Approving a site plan to expand the parking and stormwater management areas at 421 Glacier Moraine Drive, Stoughton, WI.

File Number:	R - 17 - 2020	**Date Introduced:**	August 25, 2020

EXCLUSIVELY ROSES
STOUGHTON BUSINESS PARK
421 GLACIER MORAINE DR. STOUGHTON, WI 53589
SITE PLAN

August 14, 2020

C101

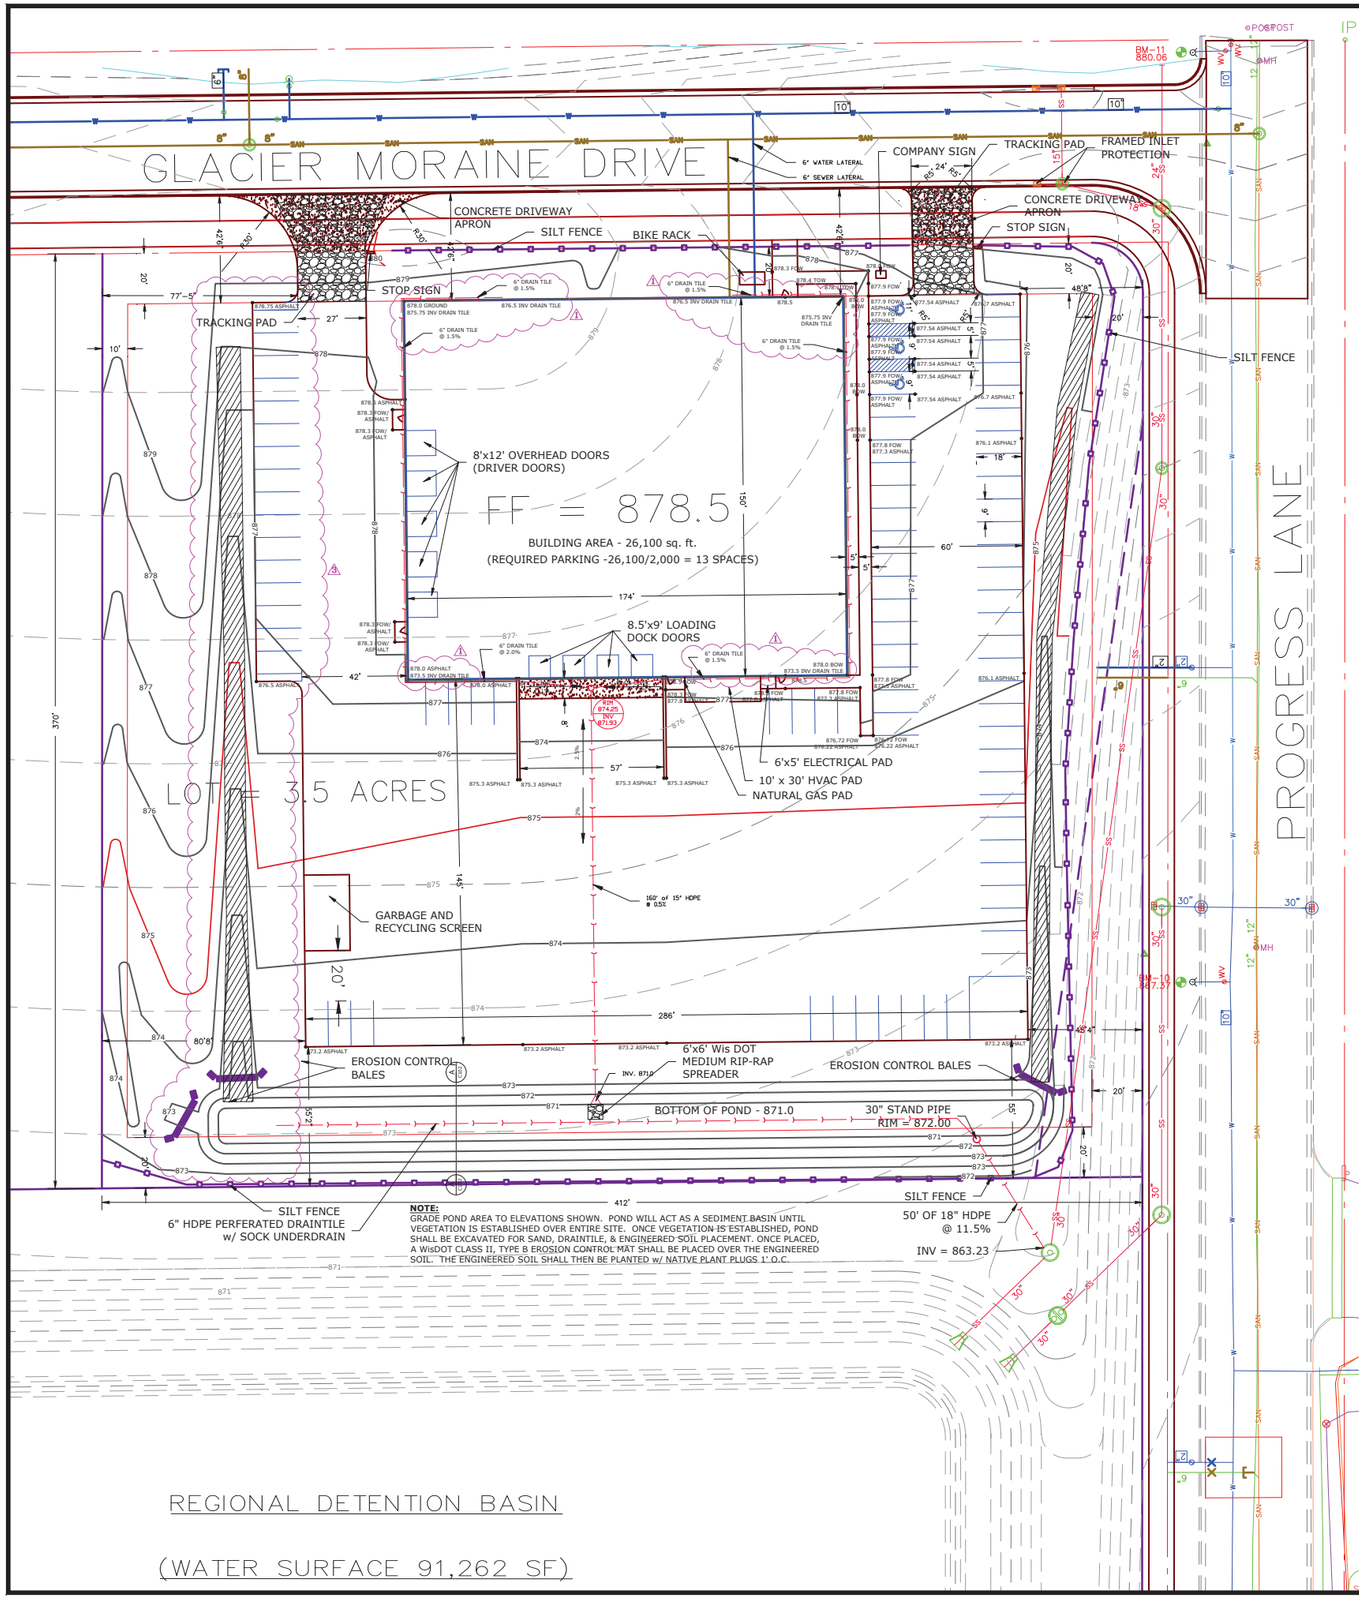
Parking requirements: One space per each employee on the largest work shift. **Sixty employees require sixty parking spaces. Eighty-two spaces are provided. The street cannot be used for required parking.**

4. The parking aisle width for 90 degree parking shall be a minimum of 24 feet. **The plan meets this requirement.**

6. Except for handicap parking stalls, the minimum parking stall length shall be 18 feet with a minimum width of 9 feet. **The plan meets this requirement.**

10. The minimum paved surface setback from a side lot line is 5 feet while the minimum is 10 feet from a right-of-way line. **The plan meets these requirements.**

13. A landscaping plan which meets the requirements of Article VI of the zoning code will need to be provided. **<u>The original approved plan will need to be updated to take into account the added paved area.</u>**

15. The minimum landscape surface ratio is 25 %. **The site meets this requirement.**

16. An updated stormwater management plan has been provided for review.

ORIGINAL APPROVED PLAN

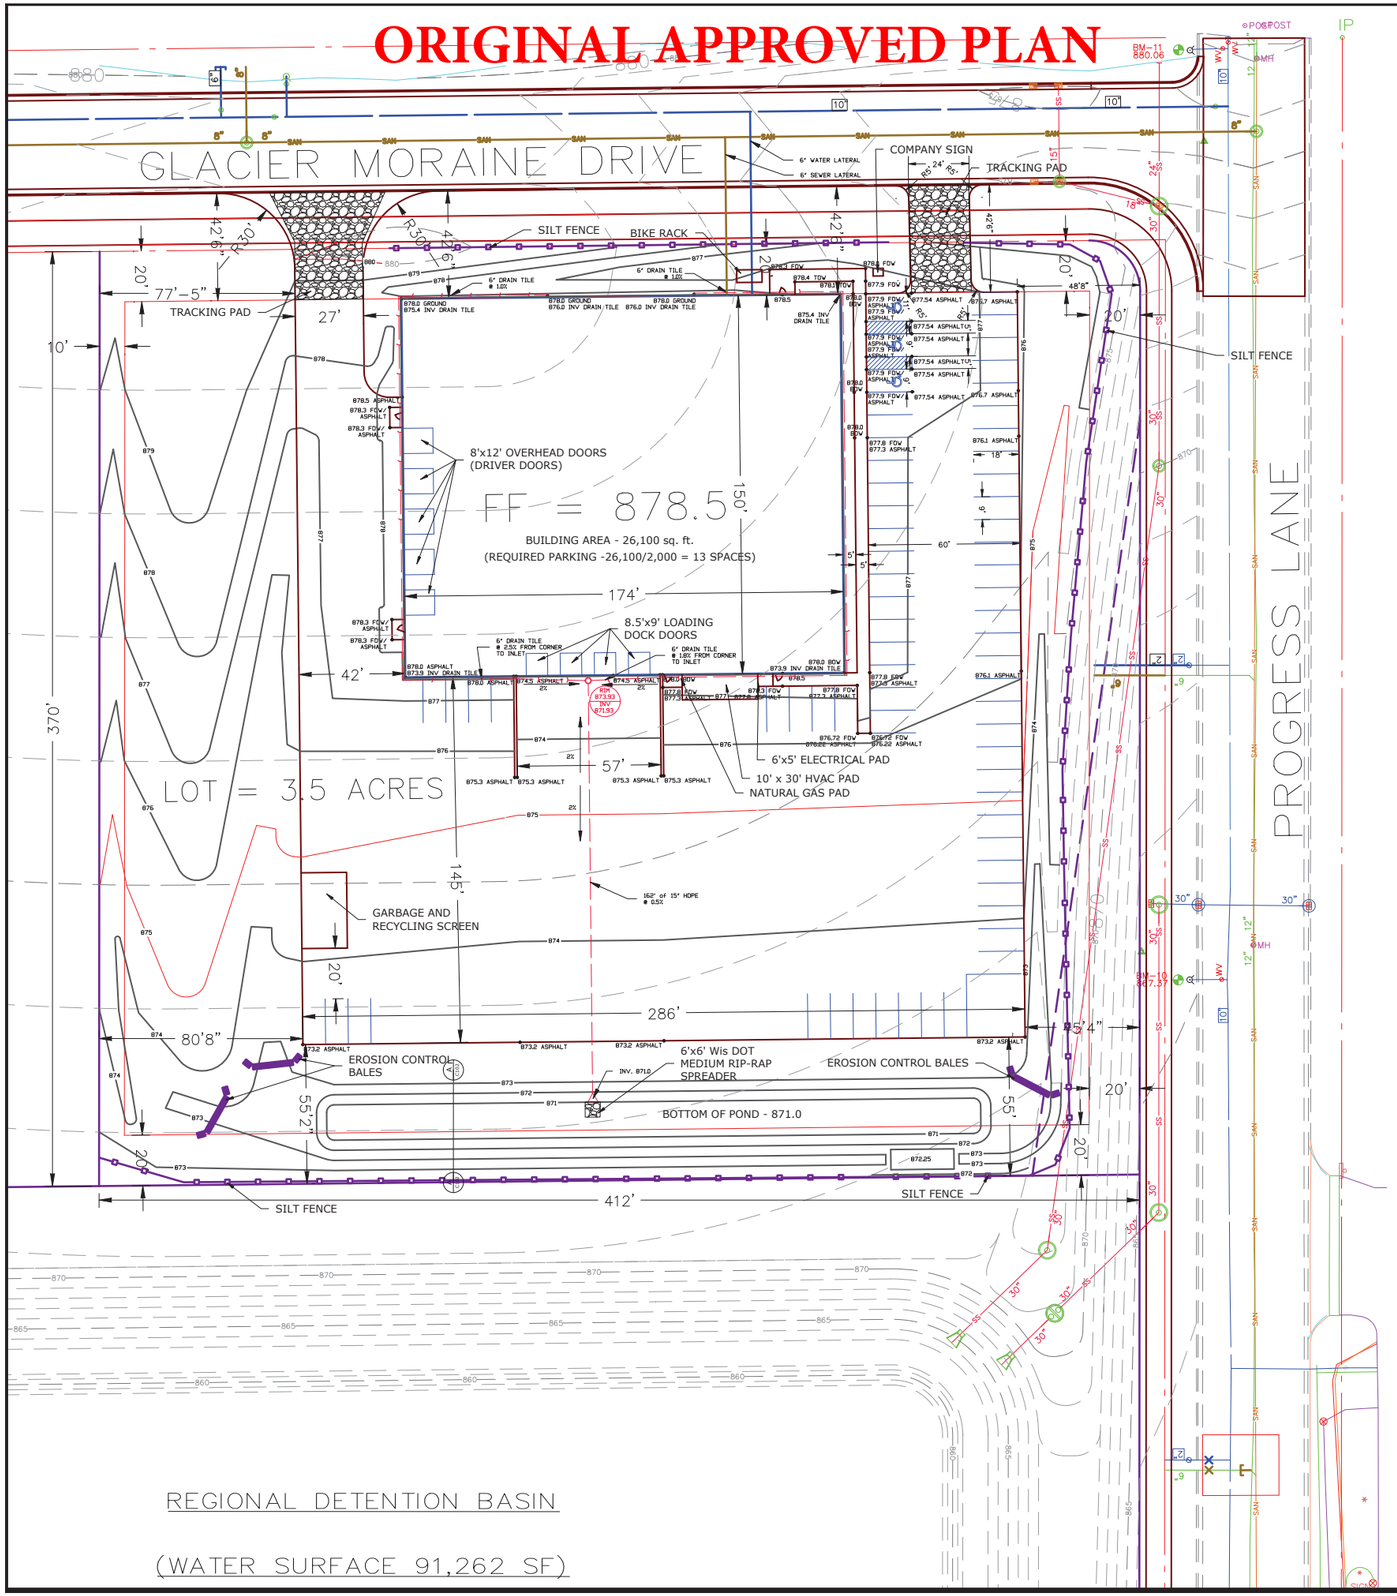
We are proposing to add an additional 18' x 150' asphalt parking area along the west side of the parking lot to help accommodate our seasonal spikes when we rent delivery vans. With the 16 additional stalls, it will help us still allow for employee parking in our lot and avoid excessive street parking use. Please call or email Bradford Anderson with additional questions or concerns.
